HISTORIC AND DESIGN REVIEW COMMISSION

January 20, 2016

HDRC CASE NO: 2015-245
COMMON NAME: 114 CEDAR, 139 CEDAR, 223 CEDAR, 311 PEREIDA
ADDRESS: 133 CEDAR ST
LEGAL DESCRIPTION: NCB 935 BLK B LOT 7 & 8 & N 12.4 FT OF 9
ZONING: MF33-S H
CITY COUNCIL DIST.: 1
DISTRICT: King William Historic District
APPLICANT: Jim Bailey/Alamo Architects
OWNER: Stephen Yndo/Children's Shelter of San Antonio
TYPE OF WORK: New construction, relocation of historic structure
REQUEST:

CEDAR AT PEREIDA

SITE PLAN

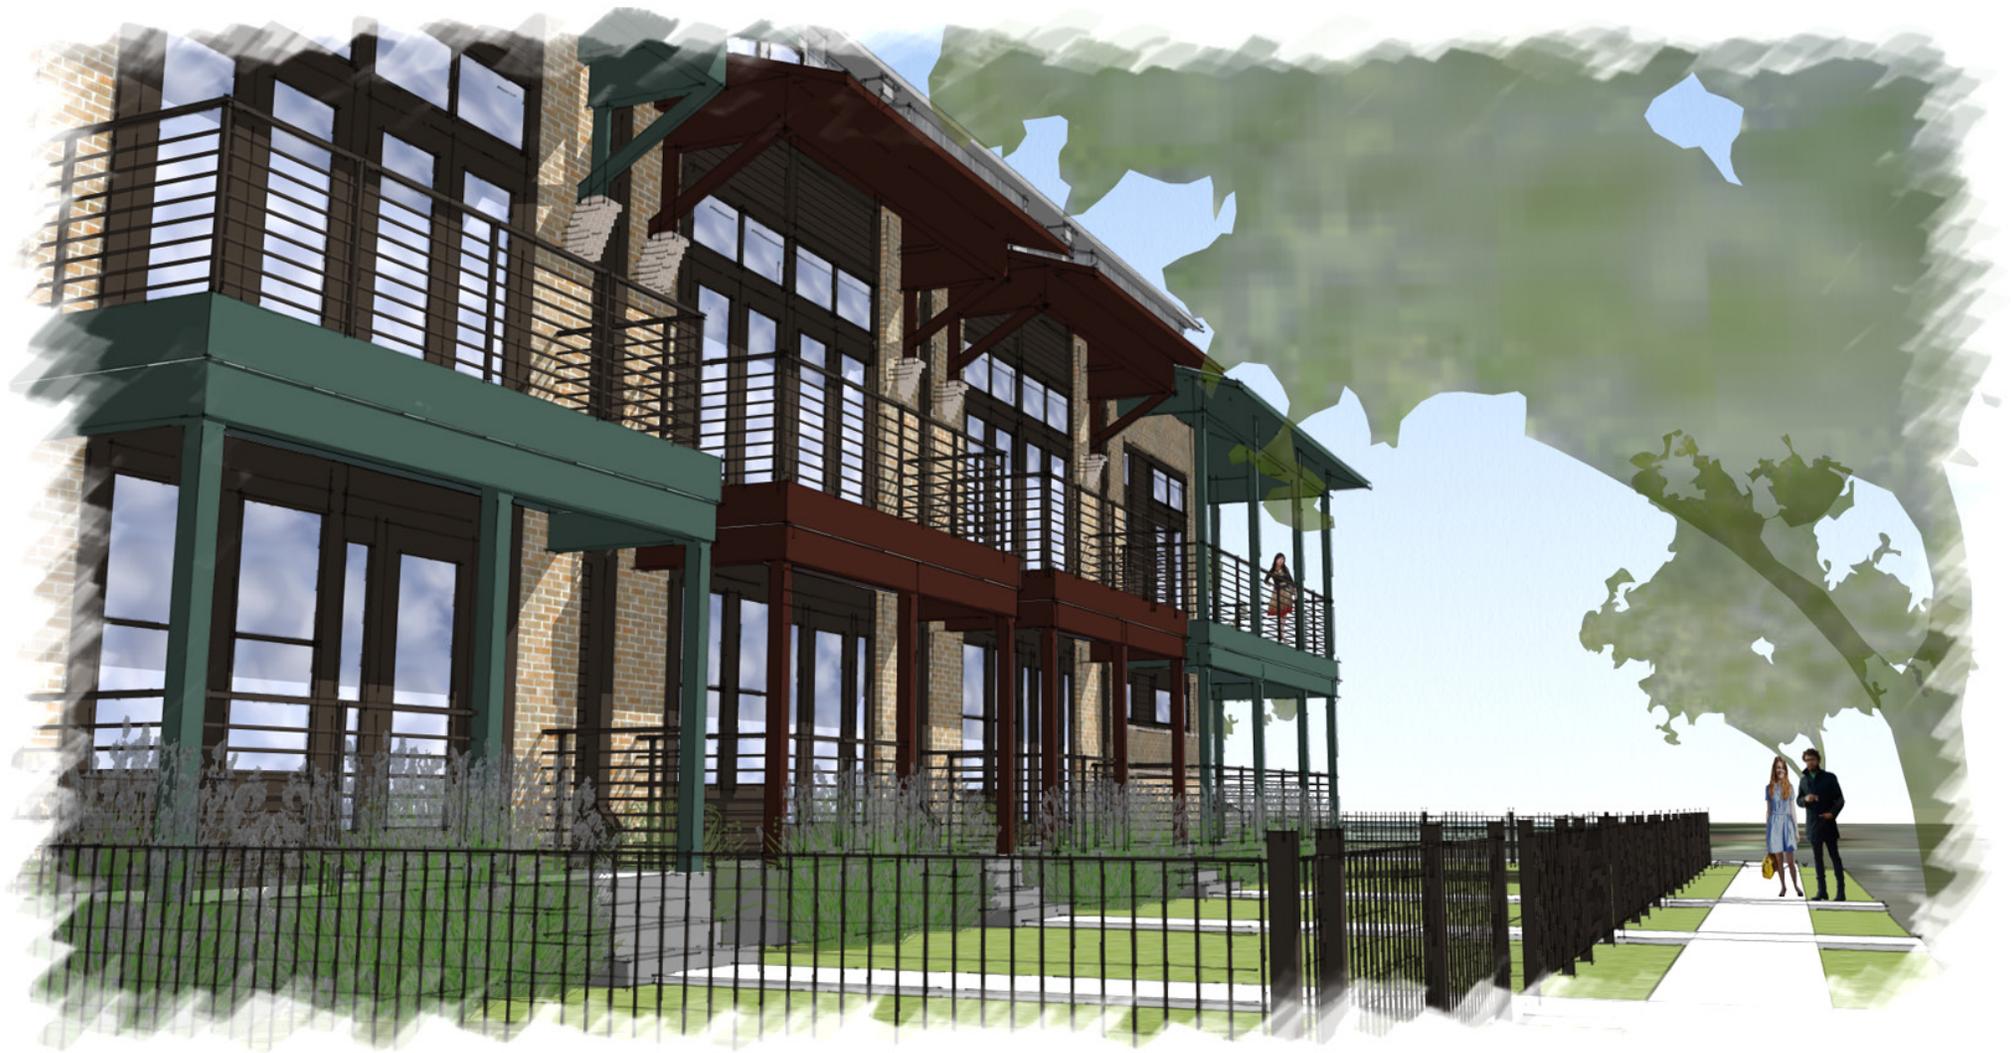
- l. The applicant has provided a site plan noting existing trees on the property. The applicant is responsible for complying with the Historic Design Guidelines for Site Elements 3.D. as well as the UDC Section 35-525 in regards to tree preservation. Species selection and planting procedure should be done with guidance from the City Arborist.

- m. Neither proposed structure will utilize a traditional driveway that is consistent with those that are existing along Cedar and Pereida. The applicant has proposed entrances as well as driveways that are approximately twenty (20) feet in width. While not consistent with the existing driveways in regards to width, the applicant has proposed to construct the driveway for Unit A on the secondary street for this structure, Pereida. The applicant has proposed to construct two (2) driveways for Unit B, both of which will provide access to and from Cedar. While wider than recommended by the Guidelines for Site Elements, staff finds that the width of the proposed driveways is appropriate considering the number of automobiles that will utilize the proposed driveways.

- n. The applicant has proposed onsite parking at the sides of the proposed driveway for Unit B. According to the Guidelines for Site Elements 7.A. and B., parking areas should not be added within the front yard setback, off-street parking should be accessed from alleys or secondary streets rather than from principal streets whenever possible and that off street parking should be screened. While the applicant's proposed off-street parking is to be accessed from a primary street, screening has been proposed and the proposed parking begins at the rear of the front yard setback. This is consistent with the Guidelines.

TYPICAL INSET WINDOW DETAILS

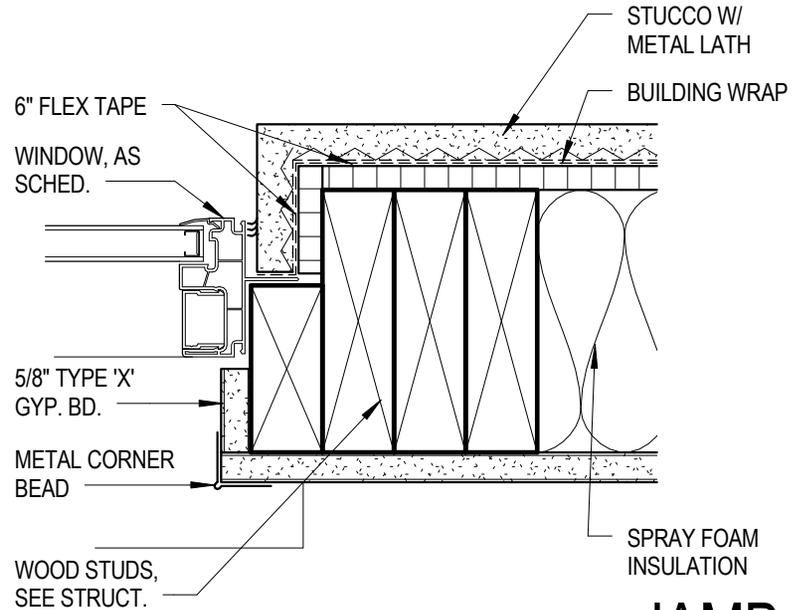
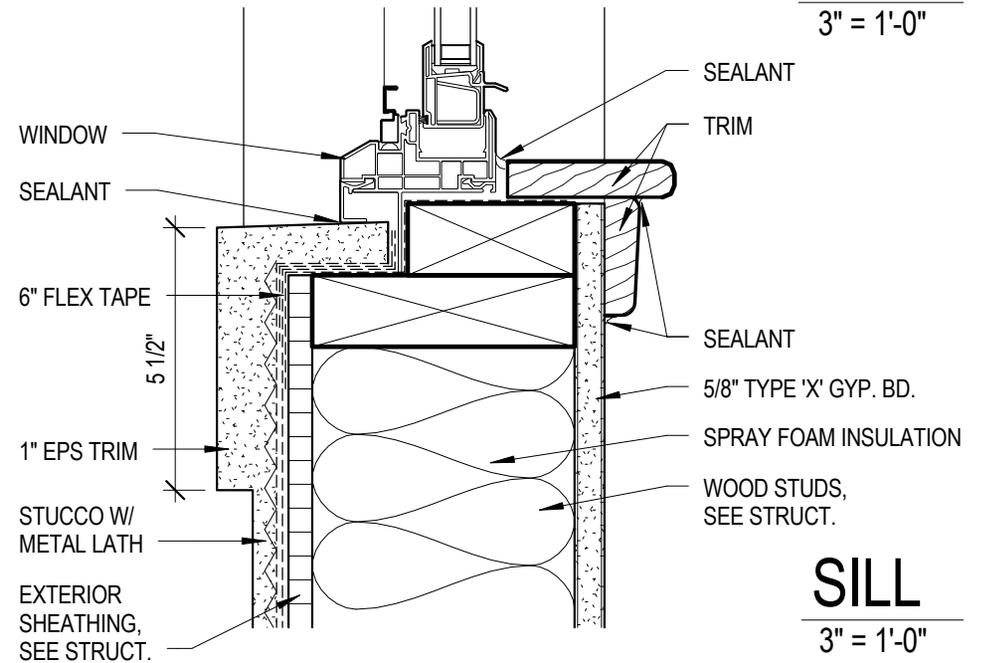
Staff recommends approval based on findings a through o with the stipulation that the applicant submit additional information to staff regarding window framing and associated façade depth.
